DOCUMENT CHANGE REQUEST

DCR number 449	Changes required for: N/A	Originator: Benoit Cornanguer
Date: 2008/12/04	Date sent: 2008/12/04	Organisation: CNES
Status: IMPLEMENTED

Title:	Diodes Switching, based on types 1N5807 through 1N5811		
Number:	5101/013	Issue:	1

New variants 11 & 12 introduction with LCC2 B package (gold finish and hot solder dip).

Figure 2(b)- Variant 11 to 12 - Leadless Chip Carrier 2 (LCC2B) – 2 Terminal

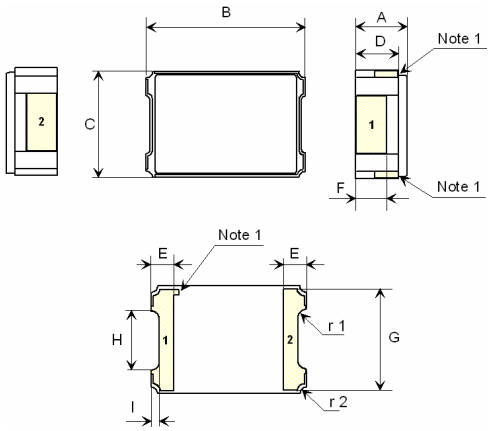
Ref	Dimensions					
	Millimeters			Inches		
	Min	Typ	Max	Min	Typ	Max
A(2)	2.04	2.23	2.42	0.080	0.088	0.095
B	5.27	5.40	5.60	0.207	0.213	0.220
C	3.49	3.62	3.76	0.137	0.143	0.150
D	1.71	1.90	2.09	0.067	0.075	0.082
E	0.48		0.71	0.019		0.028
F	1.4			0.055		
G	3.32			0.131		
H	1.82			0.072		
I	0.15			0.006		
r1	0.15			0.006		
r2	0.20			0.008

Notes:
1. The anode is identified by metallization in two top castellation and by the index mark on the bottom metallization n°1.
2. Measurement prior to solder coating the mounting pads on bottom of package.

Justification .
Variant 11: new ST variant introduction with LCC2B package
Variant 12: new ST variant introduction with LCC2B package
